UNITED STATES PATENT AND TRADEMARK OFFICE

APPLICATION NO.	FILING DATE	FIRST NAMED INVENTOR	ATTORNEY DOCKET NO.	CONFIRMATION NO.
10/540,931	06/29/2005	Iturgoyen Sabando	001058.00021	3370

Office Action Summary

DETAILED ACTION

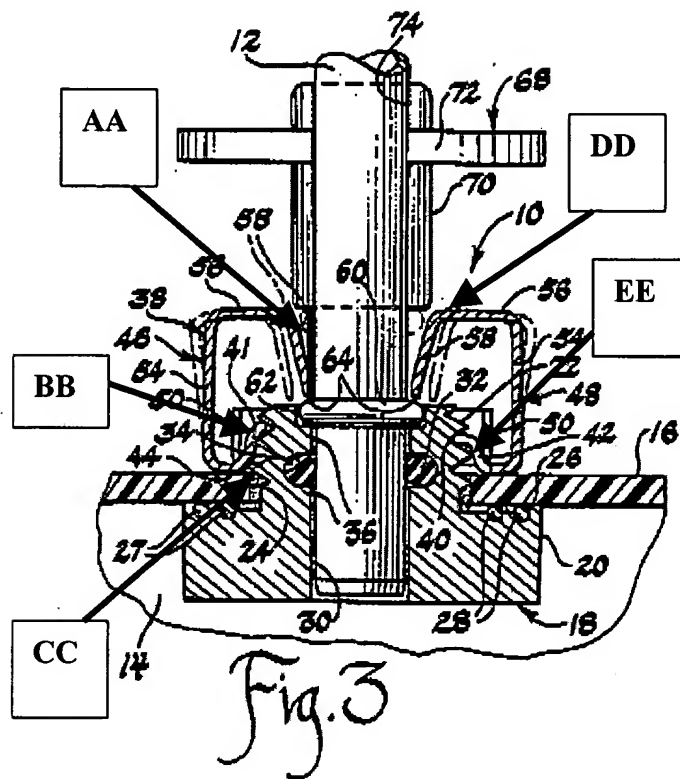
12. Claims 1-2 are rejected under 35 U.S.C. 102(b) as being anticipated by Beamer U.S. Patent No. 4,756,558.

With regard to claim 1, and as shown in Figure 3 below, Beamer discloses a quick connecting device for ducts in motor vehicles intended for quick connecting the end of a first duct 18 to the end of a second duct 12, said one end of said first duct being adapted for snugly receiving a fastening clip 38 intended to hold axially in place the ends of both ducts, the outer surface of the end of said second duct being adapted for being housed inside the end of said first duct and said end having a circumferential groove AA in the outer surface thereof, characterized in that, when assembled, the end of the first duct is adapted to extend outward to said end of said second duct without covering said circumferential groove thereof, the surface of the end of said first duct having outer protrusions BB, CC defining respective inner recesses adapted for receiving sealing gaskets.

With regard to claim 2, Beamer discloses that the fastening clip is provided with two substantially U- shaped coupling members, one DD of which being fitted into said circumferential groove of the end of said second duct and the other one EE being fitted into the groove defined between said outer protrusions of the end of said first duct.
